## PUBLIC HEARING MINUTES

DECEMBER 17, 2013

## 2. REZONING: 516 West 50th Avenue and 6629-6709 Cambie Street

Figure 1

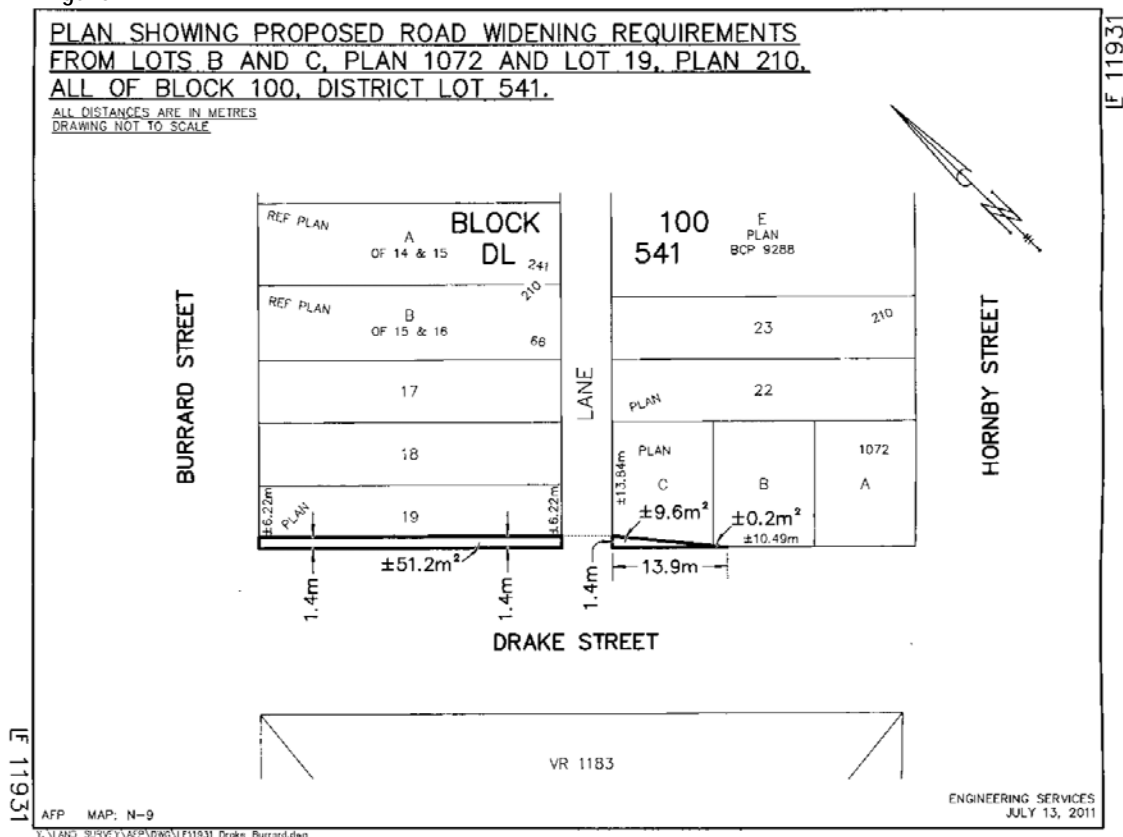
1. Consolidation of Lots 11 to 13, N1/2 of 14, A (Reference Plan 241) of Lots 14 and 15, B (Reference Plan 66) of Lots 15 and 16, and Lots 17 to 19, all of Block 100, DL 541, Plan 210 to create a single parcel.
2. Provision of surface statutory rights of way for public access and road purposes over the southwesterly 1.4 metres of the site from Burrard St. to the lane, adjacent to Drake St; and over the southwesterly part of the site defined by a point measured 1.4 metres along the existing northwesterly property line from Drake street, and a point measured 13.9 metres along the southwesterly property line from the lane (see Figure 1).

Diagram 1

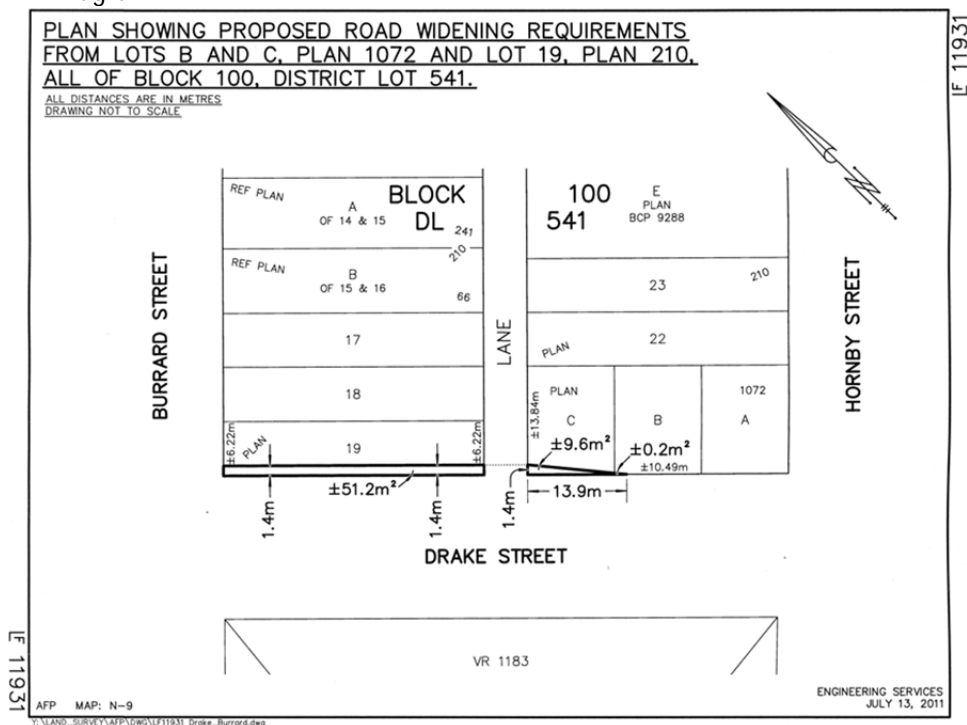
1. Consolidation of Lots 22, 23, and 26 to 33, Plan 210; Lots A, B, and C, Plan 1072; and Lot E, Plan BCP9288; all of Block 100, DL 541 to create a single parcel.
2. Provision of surface statutory rights of way for public access and road purposes over the southwesterly 1.4 metres of the site from Burrard St. to the lane, adjacent to Drake St; and over the

southwesterly part of the site defined by a point measured 1.4 metres along the existing northwesterly property line from Drake Street, and a point measured 13.9 metres along the southwesterly property line from the lane (see Diagram 1)
